**COMMISSION OF ARCHITECTURAL REVIEW
STAFF REPORT
December 19, 2017 Meeting**

9. **COA-027041-2017** (C. White)

**2200-2202 M Street
Union Hill Old and Historic District**

Construct a duplex.

1905 Sanborn Map

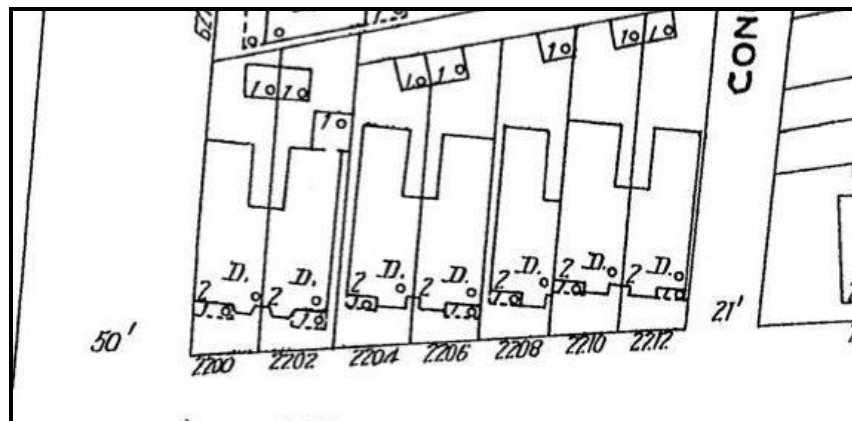
The historic pattern on the block was the projecting bay of the house to the east aligned with the front building wall of the adjacent house to the west. This was the same condition for the double houses at 2200-2202 M Street and 2204-2206 M Street which have since been demolished. The applicant has not provided a context site plan to compare to the historic pattern.
